E8364A-01C**S E R V I C E****N O T E**Supersedes:
E8364A-01B**E8364A PNA Series RF Network Analyzers**

Serial Numbers: 00000000 thru 46999999

December 6, 2007

Figure 1

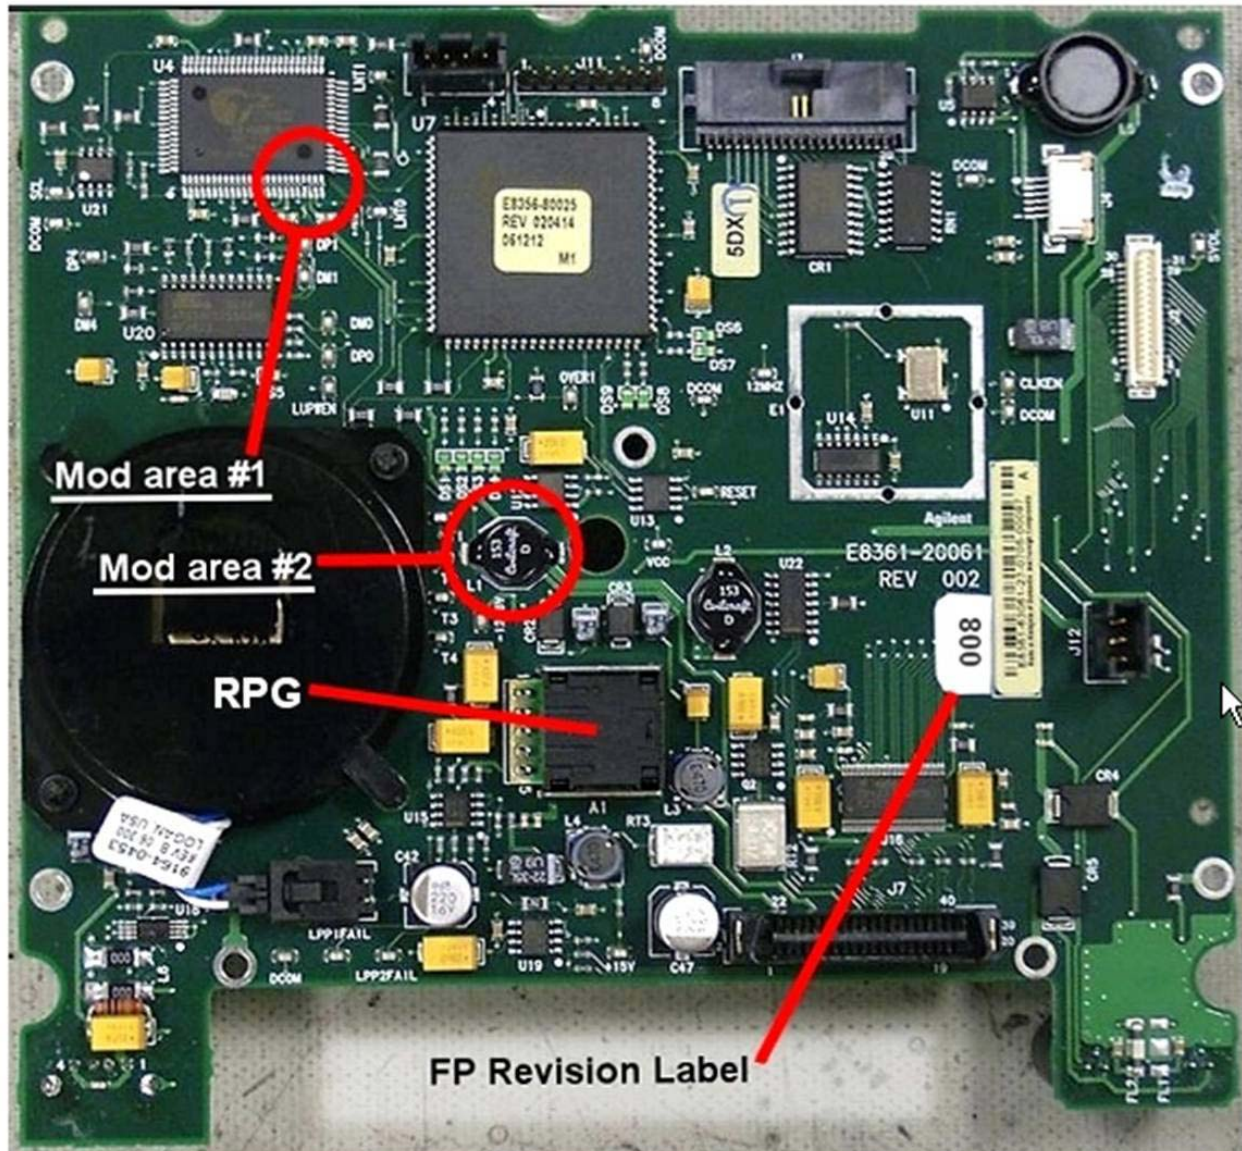
Refer to Figure 1 for the two modification areas to be addressed. Note that while this picture happens to show the FPI board completely removed from the front frame assembly, this is not necessary to perform the required modifications.

- Modification #1 consists of shorting two pins of U4 together with a small amount of solder.
- Modification #2 consist of removing L1.

Unsolder and completely remove the black surface mount inductor L1 from the front panel assembly board. This is no longer needed and can be discarded.

Figure 2

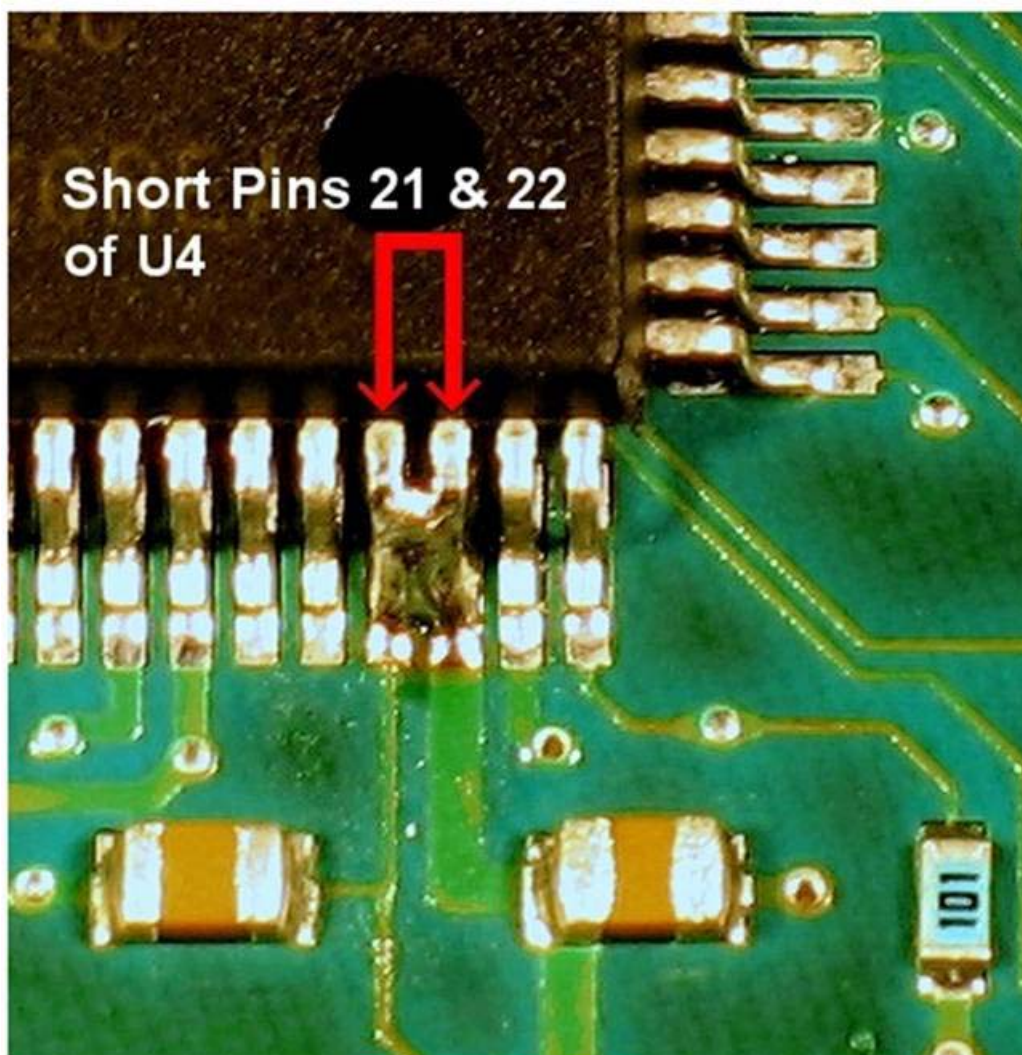
Modification #1

Carefully solder pins 21 and 22 together on U4. Refer to Figure 2 for the exact location. Use care so that no other pins are shorted. Use of a very fine tip soldering iron is recommended and a large work-task magnifying glass is very helpful.
